DEVIATION REQUEST AND DECISION FORM

Project Name :	Skyline at Lorson Ranch
Schedule No.(s) :	5500000440, 5500000274, 5500000275, 5513300005, 5513310105
Legal Description :	See Attached

A deviation from the standards of or in Section 2.5.2.(C2) of the Engineering Criteria Manual (ECM) is requested.

DEVIATION 2

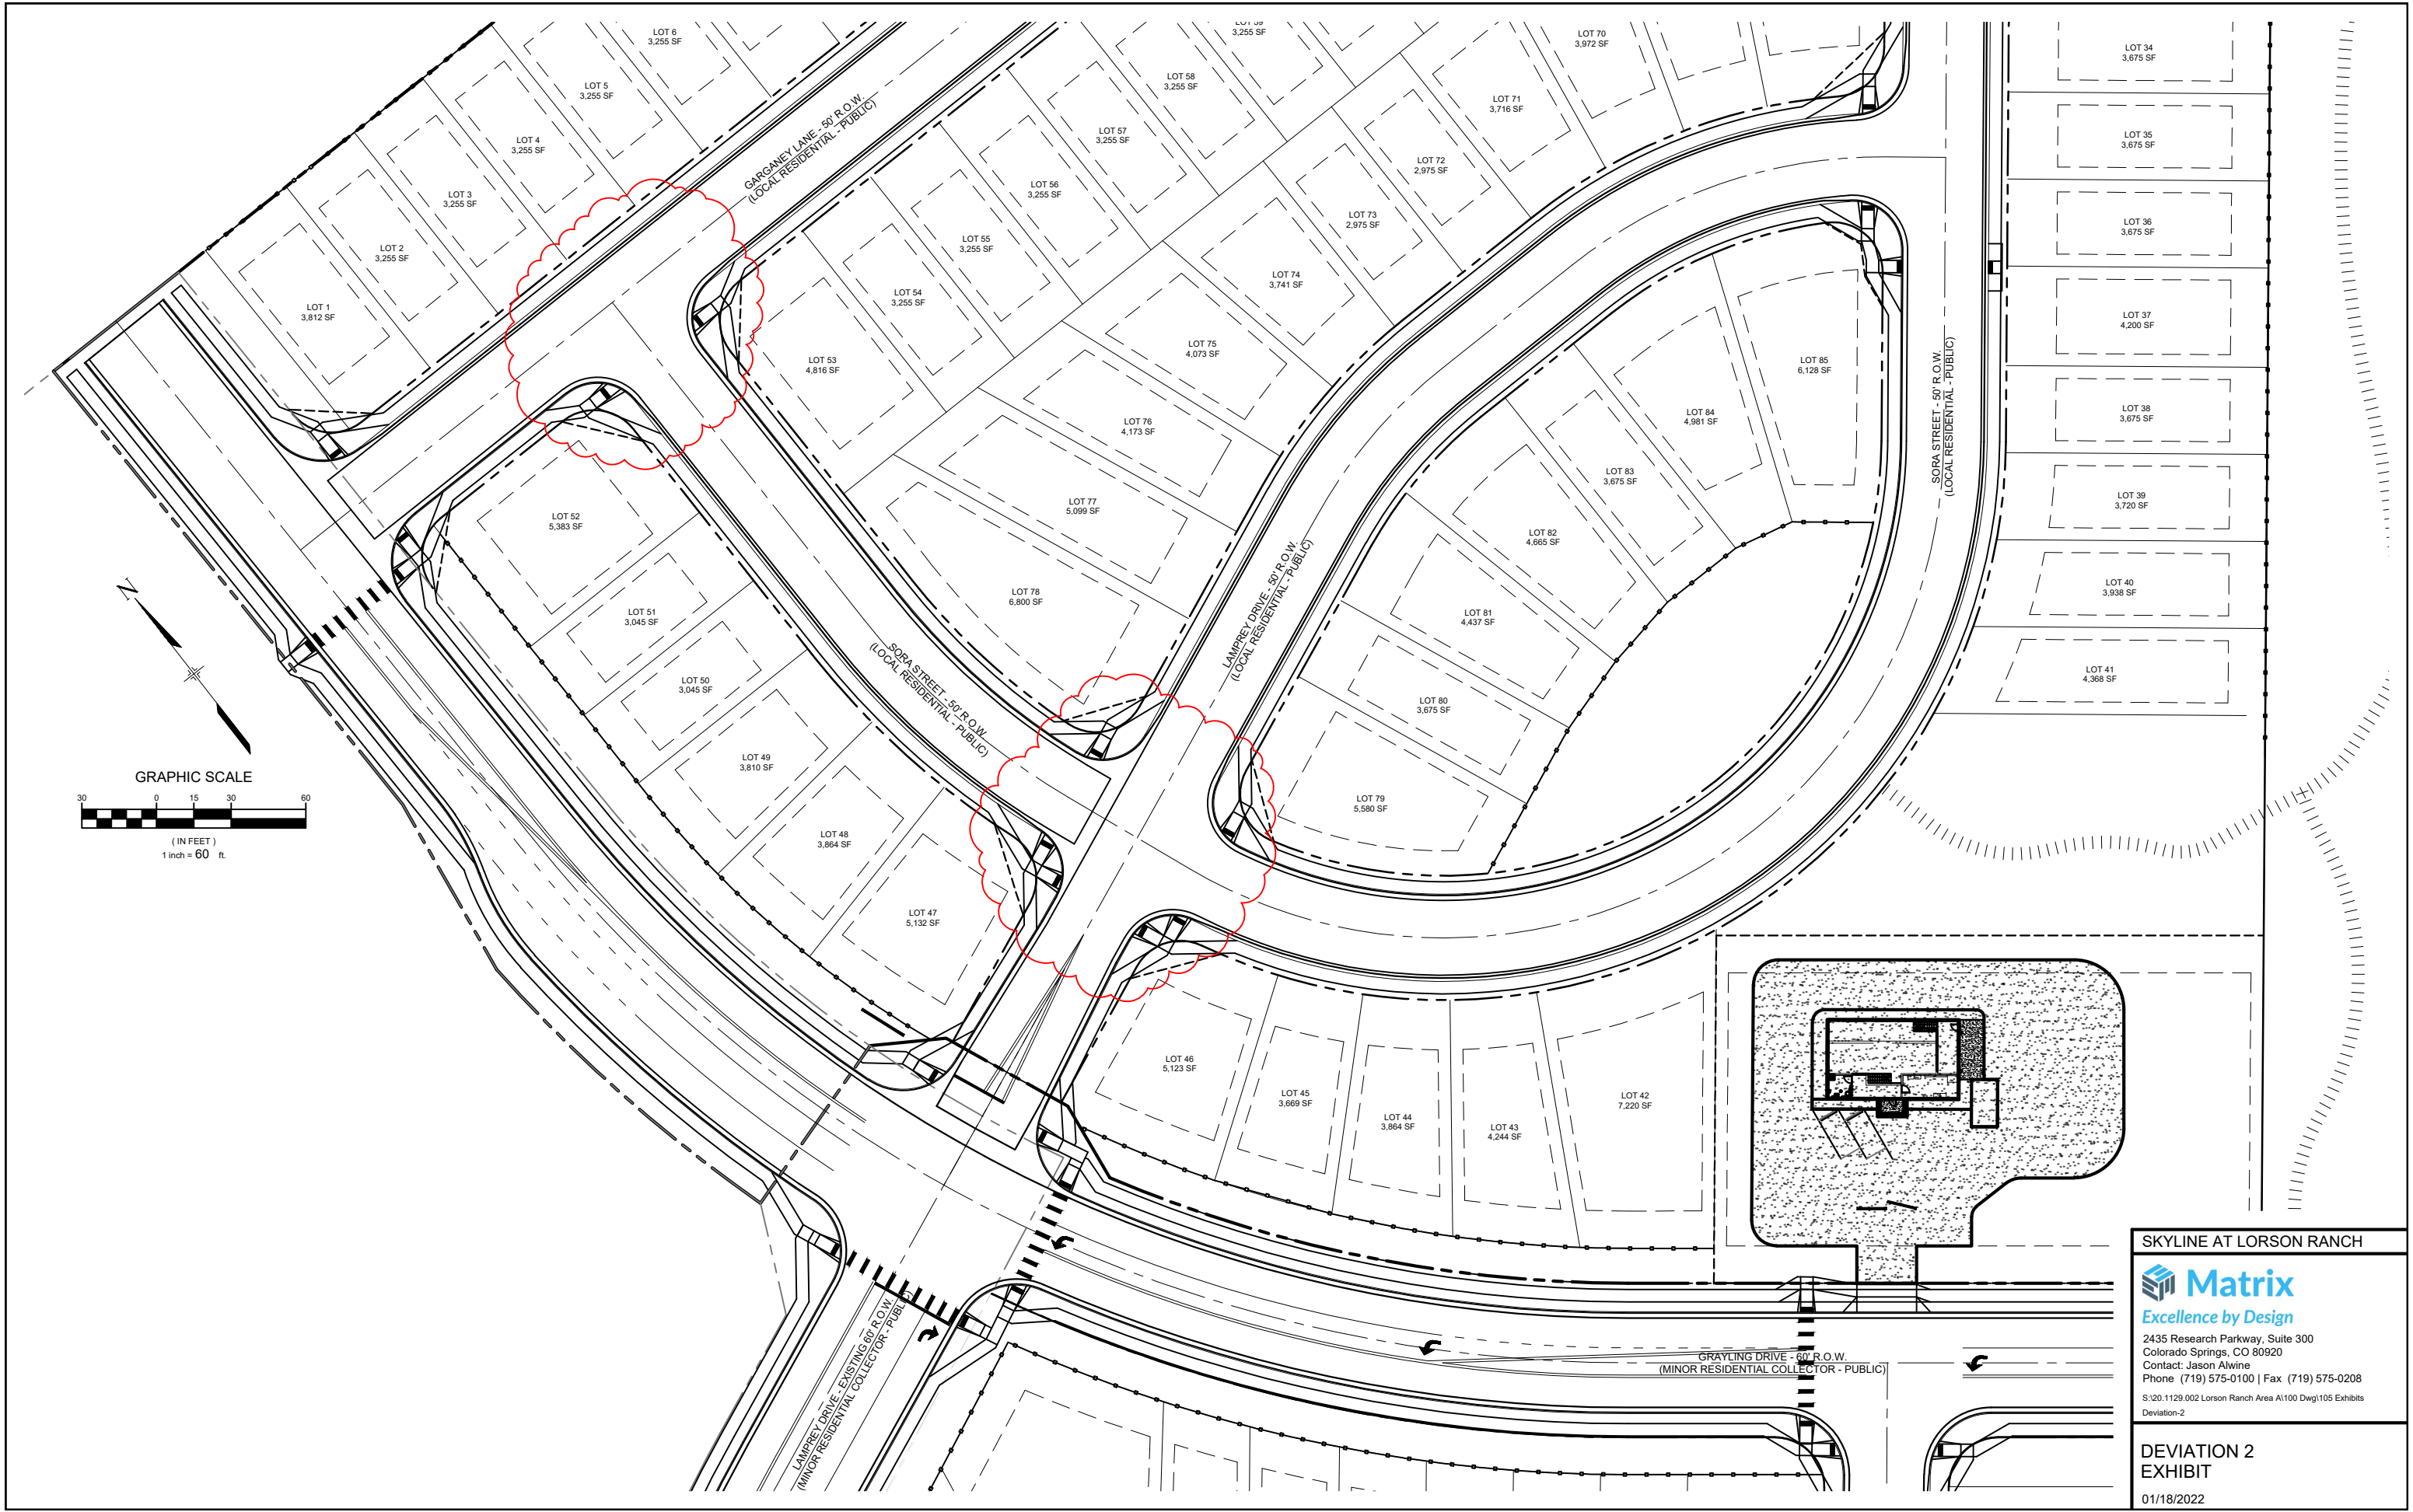
Allow only two pedestrian ramps to be constructed at the T-intersection of Garganey Lane and Sora Street and allow only six pedestrian ramps to be constructed at Sora Street and Lamprey Drive.

Both the intersections are in proximity of another intersection with all ramps installed as required. Installation of all corner ramps at these two intersections is not feasible as the grading cannot meet ADA requirements along the ADA curb returns. However, the intersections are providing multiple access points and does not limit pedestrian movements.

Elimination of ramps at each of the intersections will not impede pedestrian movements and will result in safer pedestrian crossing due to grading concerns and inability to meet ADA slope requirements (where required). A pedestrian will be able to cross at alternate locations within approximately 85' or less of the eliminated ramps.
